INDIANA DEPARTMENT OF TRANSPORTATION

STANDARDS COMMITTEE MEETING AGENDA

RE: Agenda for the November 16, 2006 Standards Committee Meeting

Item No. 16-7
Ms. Rearick
Date: 11/16/06

Figure 67-1 C (1)

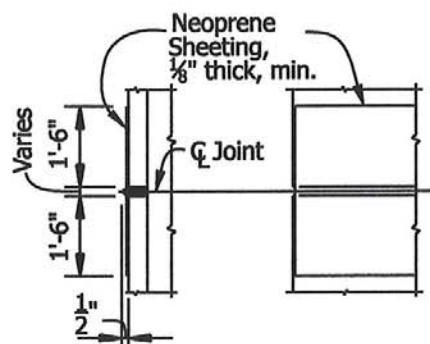
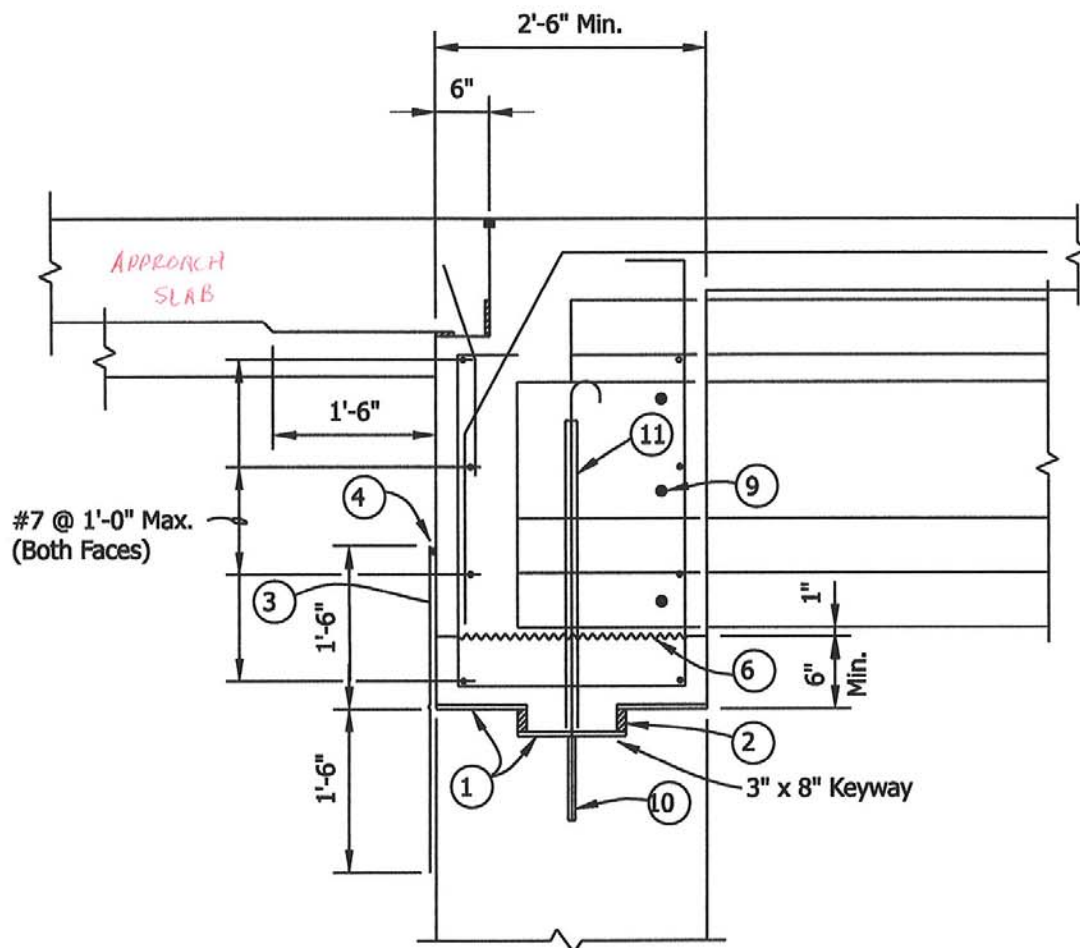
Semi-integral end bents should be considered for each bridge for which integral end bents are not practical or feasible. For a skew angle of greater than 30 deg or an expansion length of 250 ft (80 m) or longer, twisting or racking of the bridge should be investigated.

Indiana Design Manual Figure 67-1C(1) shows details for Method 1, and Figure 67-1C(2) shows details for Method 2. Both figures are attached hereto. All applicable information shown in the figures should be shown on the plans.

STANDARD DRAWING NO. E 715-BKFL-01

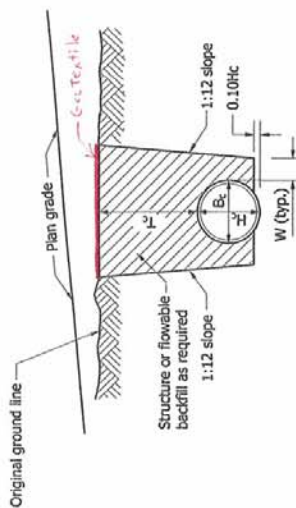
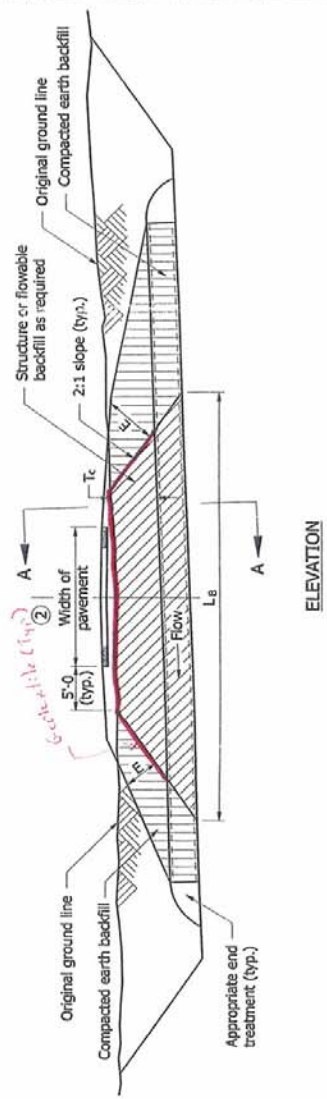
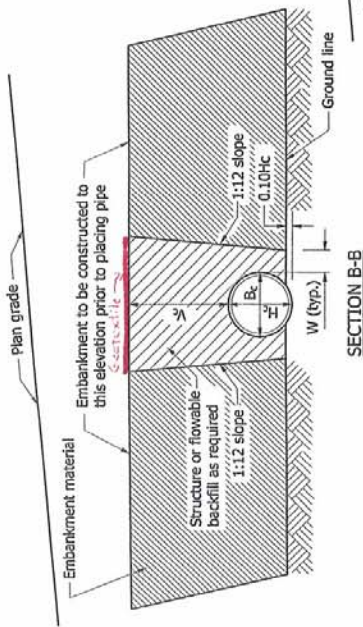
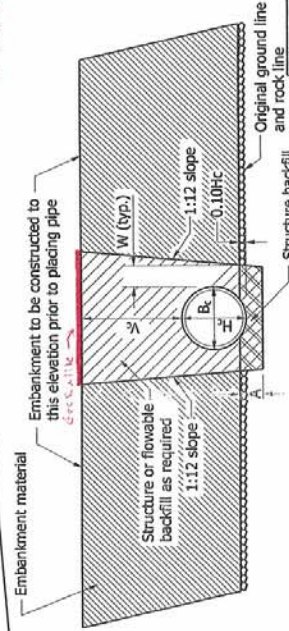
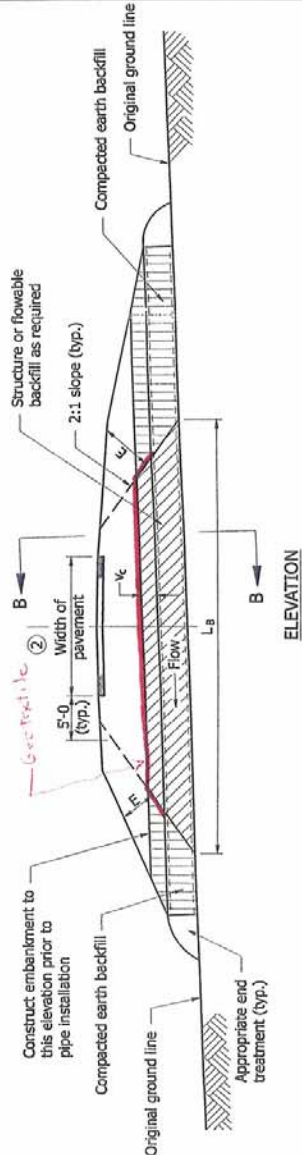
The above proposed standards are to replace the following existing standards
715-BKFL-01 thru 12.
